11 July 2022

Our Ref: R/2020/17/B  
Your Ref: SSD-12618001

**Advice on Response to Submissions - 104-116 Regent Street, Redfern - Student Accommodation (SSD-12618001)**

**Fig. 1** Ground floor with area suggested as food & drink premises circled in red

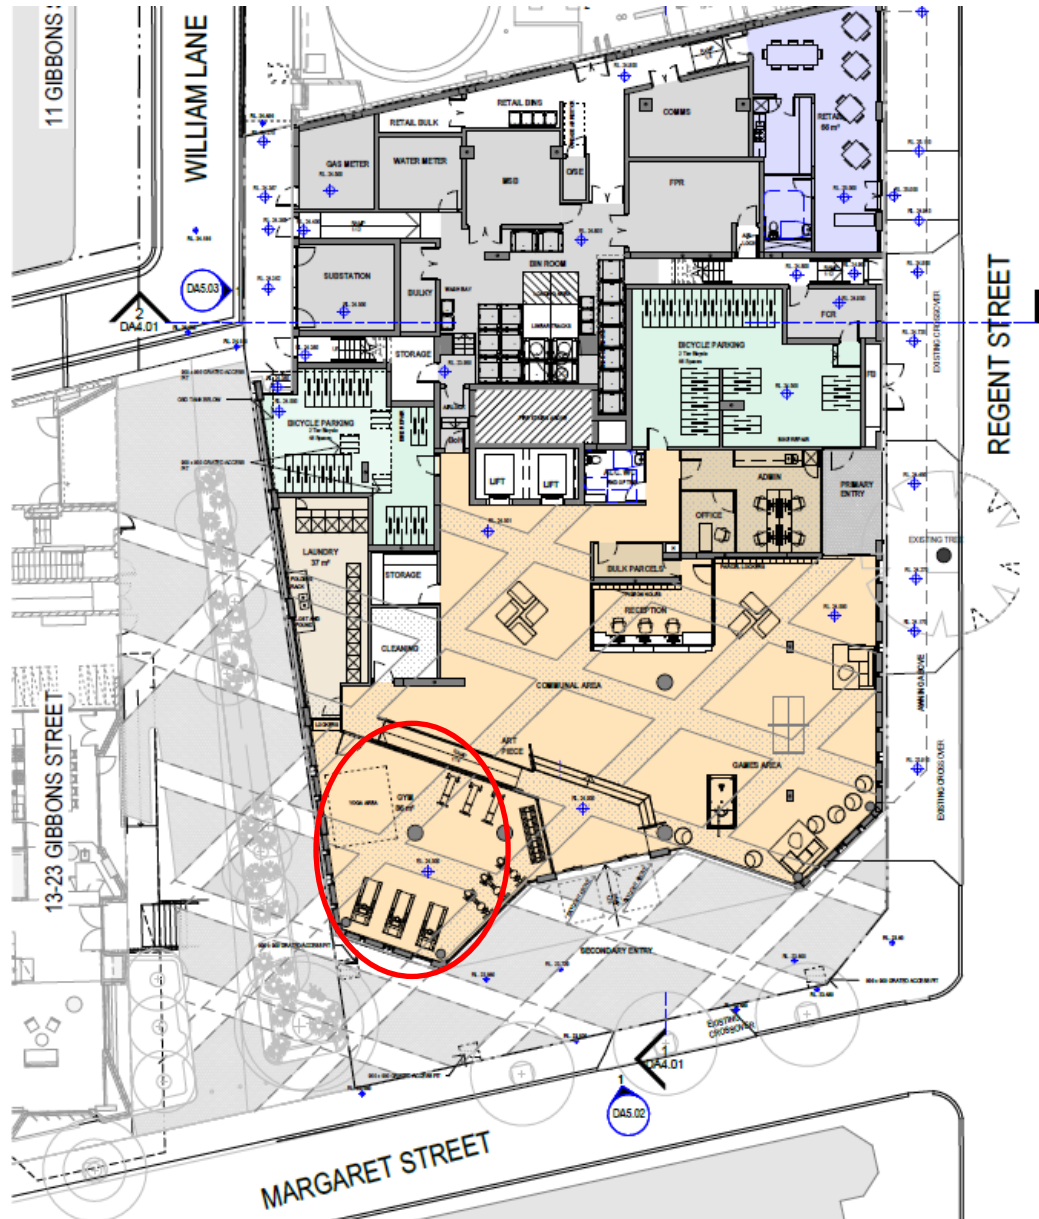
However, the response is inadequate and collectively, the development fails to provide activation to the other frontages on Margaret Street and future through-site link and pedestrianised extension of William Street. This is a missed opportunity for good place making.

The proposed gym area on the south-western corner of the ground floor is an ideal location for a food and drink premises that could activate Margaret Street along the southern boundary and the pedestrianised William Lane extension on the western boundary (refer to **figure 1**). The provision of a food and drink premises at this location will not only attract residents but also locals and pedestrians and would achieve the objectives of an active frontage, away from the heavy volumes of traffic down Regent Street with its associated air and noise pollution. The food and drink premises would be visible from Regent Street and Margaret Street and could have an internal link to the proposed internal laundry immediately adjacent to the space on the ground floor, providing students with greater amenity and convenience.

Further, the City reiterates previous comments in relation to the 2.8m floor to ceiling heights of the ground floor retail tenancy on Regent Street. This presents as a residential scale and should be increased.
